STATE OF UTAH  
NATURAL RESOURCES  
Oil, Gas & Mining

Re: Application for Permit Modification, Utah Fuel Company,  
Skyline Mine, ACT/007/005, Carbon County, Utah

APPLICATION FOR PERMIT MODIFICATION

SKYLINE MINES

Design

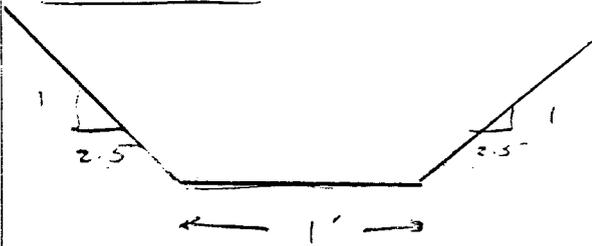
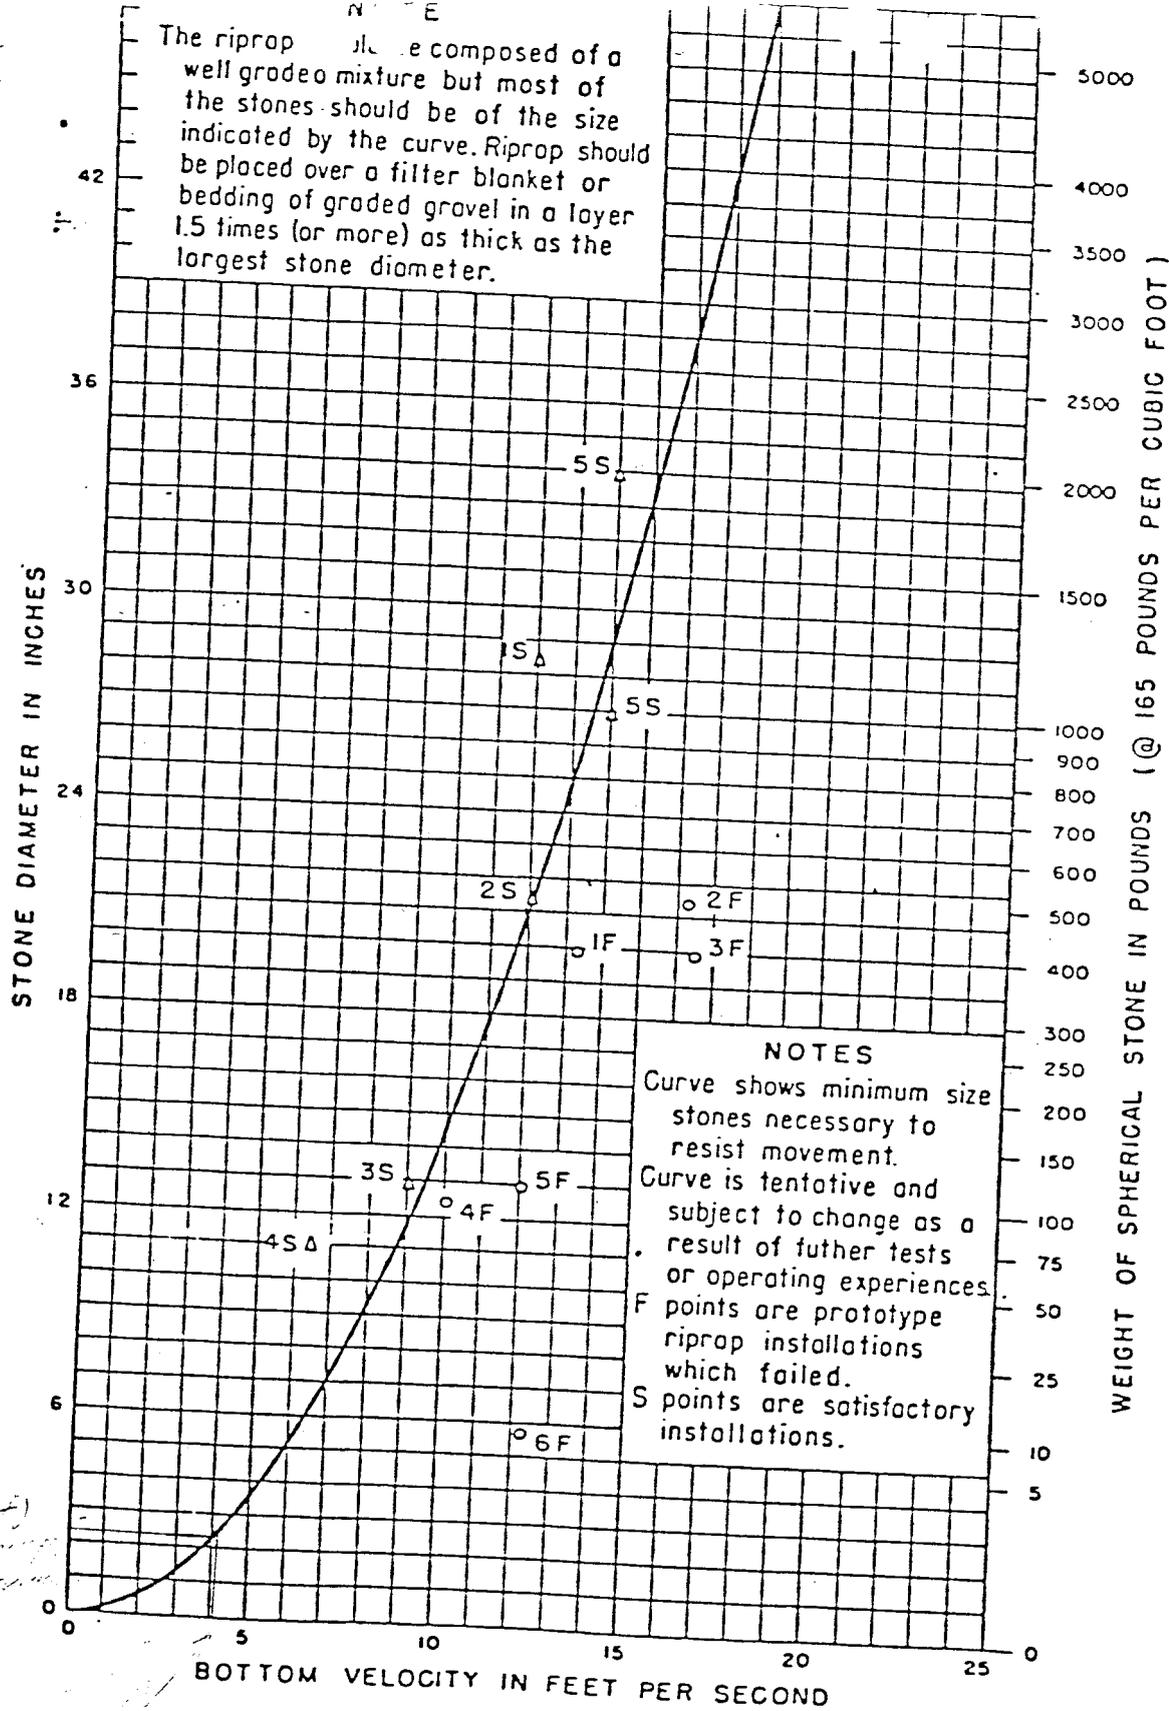
Analysis of the proposed 2 inch riprap indicate that the riprap is adequate for the expected flow velocities (4.01 fps) resulting from a 50 yr - 24 hr event. Since the regulations only require a 10 yr. -24 hr. design, the diversion is over designed and should be approved (see attached technical memo for calculations and rationale). I recommend that we revise the condition referenced above as follows:

2" riprap adequate.

Condition #1 (revised). The applicant must commit to installation of a channel lining of two (2) inch material in diversion BC-12 prior to July 15, 1986. The diversion must be riprapped to provide for a depth of flow of 1.0 ft. for the entire reach.

Design for 50yr event (agreed by Russell & Welch 3-14-86).

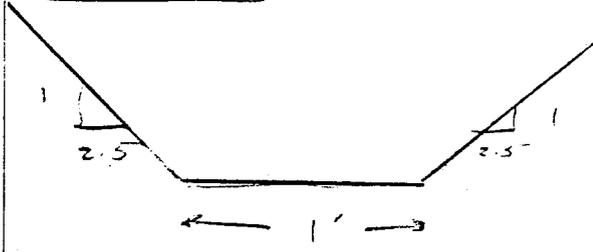
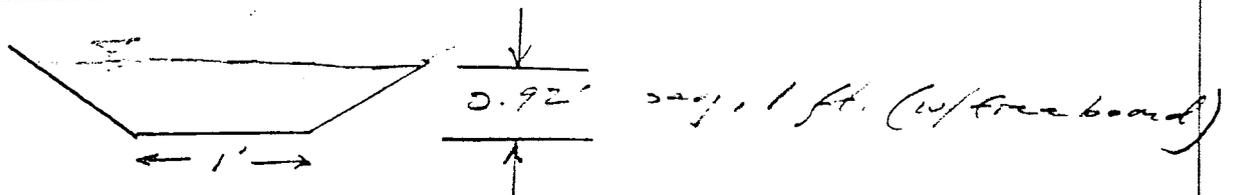
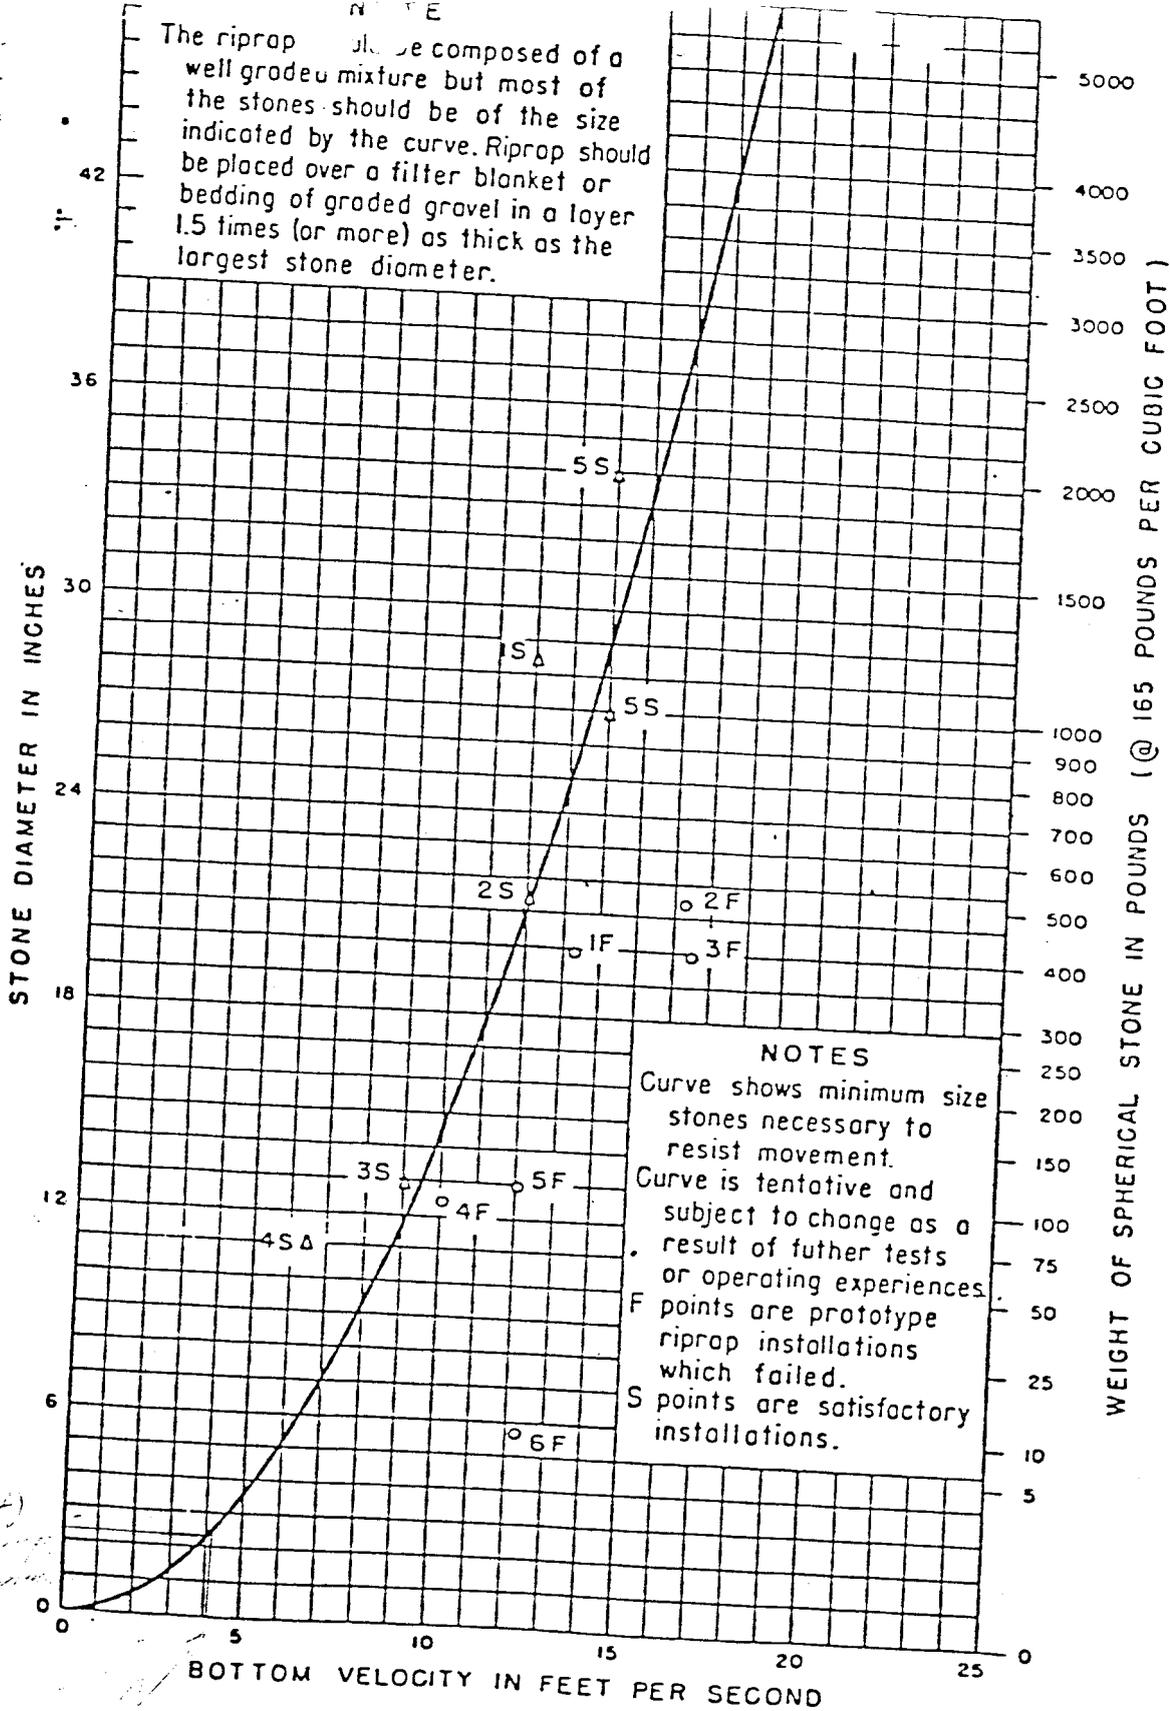
Analysis of the proposed 2 inch riprap indicate that the riprap is adequate for the expected flow velocities (4.01 fps) resulting from a 50 yr - 24 hr event. Since the regulations only require a 10 yr. -24 hr. design, the diversion is over designed and should be approved (see attached technical memo for calculations and rationale). I recommend that we revise the condition referenced above as follows:

Velocity = 4.01 fps

see attached chart:

Condition #1 (revised). The applicant must commit to installation of a channel lining of two (2) inch material in diversion BC-12 prior to July 15, 1986. The diversion must be riprapped to provide for a depth of flow of 1.0 ft. for the entire reach.

Design

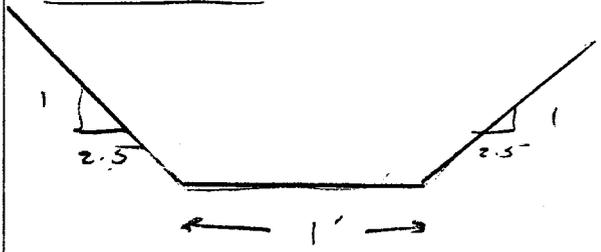
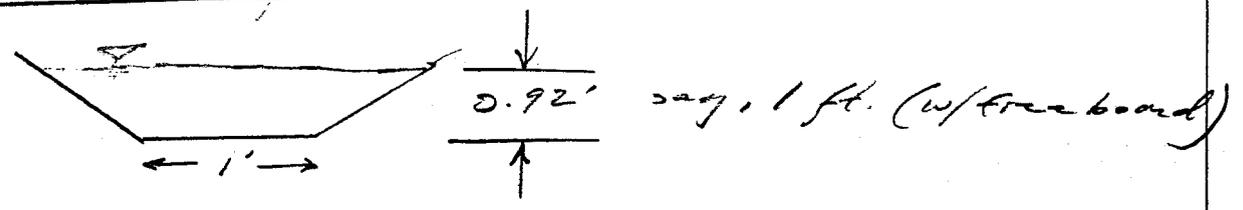
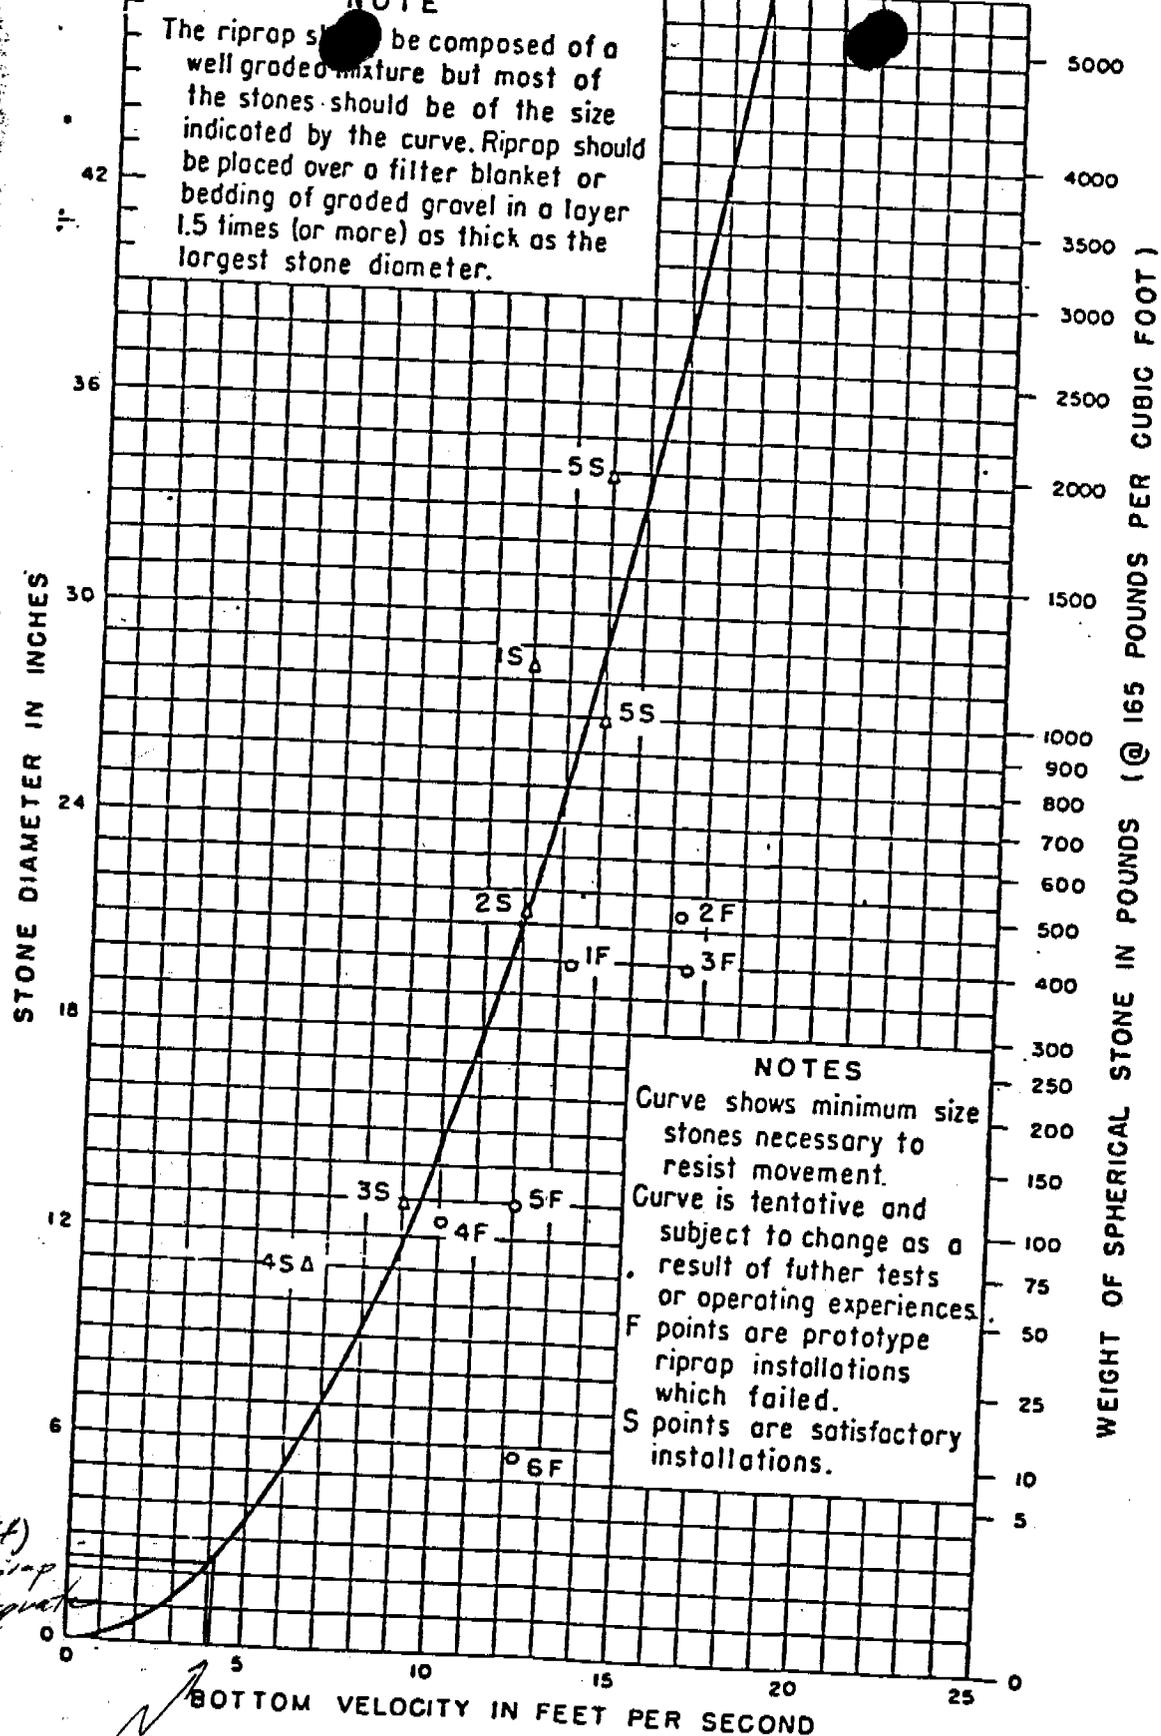
see attached chart:  
 2" riprap adequate.

2.2(A)  
 riprap  
 adequate
